SERVICE INSTRUCTION

Service Instruction No. 1423A
(Supersedes Service Instruction No. 1423)
Engineering Aspects are
FAA Approved

SUBJECT: Thermostatic Oil Cooler Bypass Valve Part Number (P/N) 75944

Figure 1
Thermostatic Oil Cooler Bypass Valve Crimp Nut

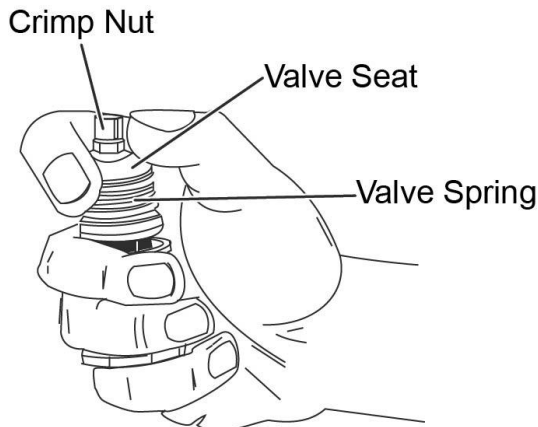
REASON FOR REVISION: Loctite® procedure for crimp nut is no longer valid. New superseding part number for thermostatic oil cooler bypass valve.

This revision of the Service Instruction identifies a change: Thermostatic oil cooler bypass valve part number P/N 53E22144 now supersedes P/N 75944 when it is necessary to replace bypass valve P/N 75944 if it is damaged, its crimp nut (Figure 1) is loose, or for any other reason.

Unless otherwise indicated in the latest revision of Service Instruction No. SI-1565, P/N 53E22144 is the only replacement bypass valve to be installed.

NOTICE: The replacement bypass valve P/N 53E22144 (that is now to be used instead of P/N 75944), does not need to be immersed in Loctite® and does not need to have the letter “L” vibro-peened on the bypass valve per the previous revision of this Service Instruction.
